PREVOST

WARRANTY BULLETIN

WB16-02B

DATE :	MAY 2016	SECTION :	06 - Electrical
EXPIRATION:	MAY 2018		
SUBJECT :	CHARGING SYSTEM IMPROVEMENT

FIGURE 48

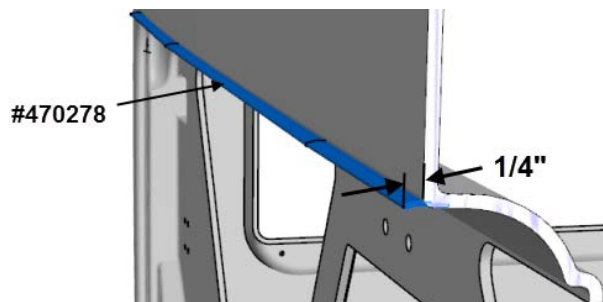
1. Page 18, step 9: 7/64" measurement increased to 1/4"
2. Page 19, step 10: drill bit diameter 9/64" changed for 7/64"
3. Page 19, step 11: note added *Use a 1/8 drill bit for the installation of the rivets*
4. Page 19, steps 13 & 14: improper drip edge number in text and in figures 51, 52. Text #470278 changed for #420152

The drip edge should extend past the panel surface by **1/4"**. The goal is to prevent water/rain from dripping on the inner side of the SCR access hatch.

9. Place drip edge #470278 in proper position. Use reference lines marked on the drip edge and vehicle body to center properly.
